Product Change Notification

Date Issued :	December 03, 2024	PCN Number :	516025
Reason for Change :	Packaging Method/Quantity Changing		
Description of Change :	This notification is to inform you about part(s) listed will undergo changes to the label material/ specification. No changes will be made to the product as a result of this change.		
Assessment of Change :	Drop Test		
Planned Implementation Date :	June 03, 2025		
Customer Sample Availability Date:	December 10, 2024		
Last date to request Samples by Customer :	December 10, 2024		
Please note if Samples are not requested as per Customer Samples Request date, it may take additional 4-6 weeks to arrange Samples.

**Before
Paper Tray**

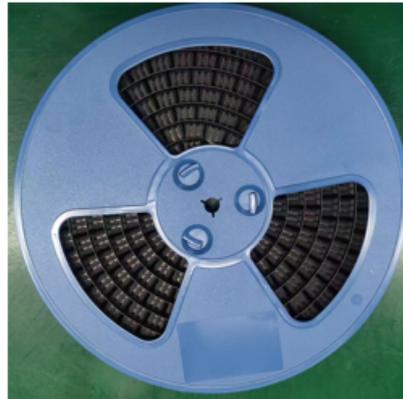
- Change packing tape reel from paper trays to plastic trays

- Change packing tape reel from paper trays to plastic trays for enhance packaging protect capabilities.
